Groundwater & Wastewater Services
Septic Project File & Data Review Worksheet

IMPROVEMENT PERMIT for a RESIDENTIAL ON-SITE WASTEWATER TREATMENT & DISPOSAL SYSTEM

GWS Septic System Design Review

RE: Request for an Improvement Permit for Lot 34 at The Retreat at Latta Plantation off of Sample Road.
MCHD File #6772B

Scale: 1 inch equals 50 feet	S&ME	Faison-Sample Road, LLC	FIGURE
Drawn by: JBP		Lot 34	
Reviewed by: Jeremy P. Michelone, RS		Mecklenburg County, NC	1
Date: March, 2007	ENVIRONMENTAL SERVICES · ENGINEERING · TESTING	S&ME Project #1588-05-091

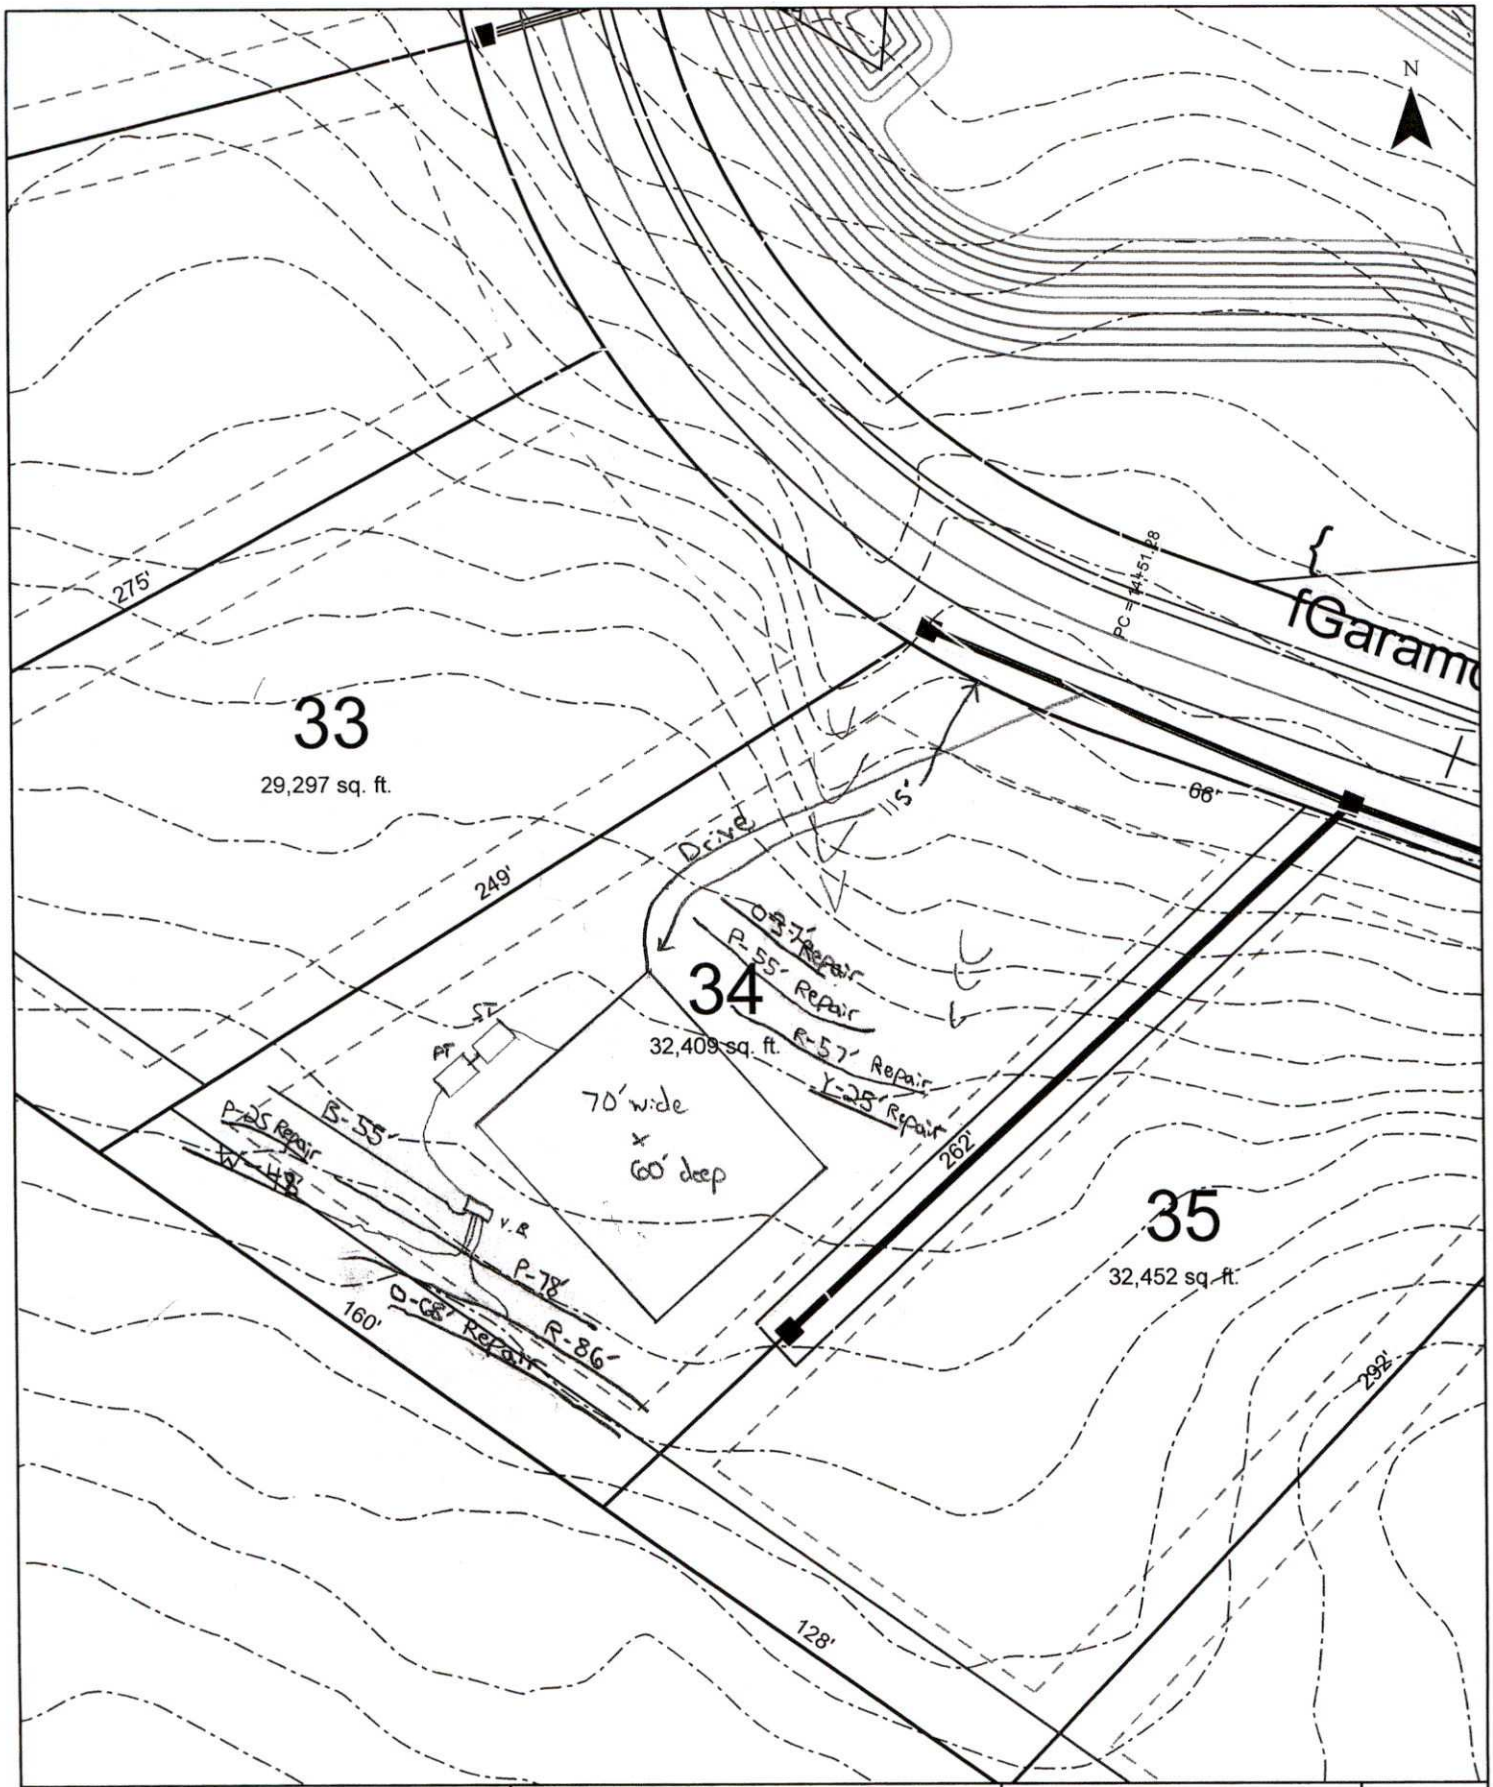
The proposed system is a TYPE IV and will require a contract with a Certified Operator to supply maintenance services for the septic system. Please review the attached system sketch and design specifications for the Improvement Permit. If necessary, the MCHD may add comments to the site plan or specifications. Please call if you have any questions or comments.

PPBPS Design Worksheet								File #:	6772B
								Tax #:	
System Requirements								Address:	Lot 34 Sample Rd.
Design Flow	480	gpd							
LTAR	0.300	gpd/ft.^2						Consultant:	Jacob Presley - S&ME, Inc.
Linear footage	533	ft. (conventional)						Phone:	336-288-7180
Linear footage	267	ft. (50% Reduction)							
								Reviewed By:	TCT
Design Layout								Date:	4-5-07 ✓
Laterals	Length (ft)	# Panels	Calculated						
Line # 1	55	13	12.69		T & J Panels				
Line # 2	39	9	9.00		Linear Feet	# Panels			
Line # 3	39	9	9.00		20	5			
Line # 4	48	11	11.08		30	7			
Line # 5	43	10	9.92		40	9			
Line # 6	43	10	9.92		50	11			
Line # 7	0	0	0.00		60	14			
Line # 8	0	0	0.00						
Line # 9	0	0	0.00		70	16			
Totals	**267**	**62**	61.62						
Absorption Area									
Length (ft)	Width (ft)	Area (ft^2)							
267	3	801							
System Pressure Head	3	ft.	Value selected by system designer (must be between 2-5 ft.)						
Orifice Diameter	5/32	in.	Size selected by system designer (1/8 in. minimum)

1. Install system using 3 ft. wide trenches.									
2. Install drainlines on 9 ft. centers, level, and on contour.									
3. System design requires effluent pump for distribution.
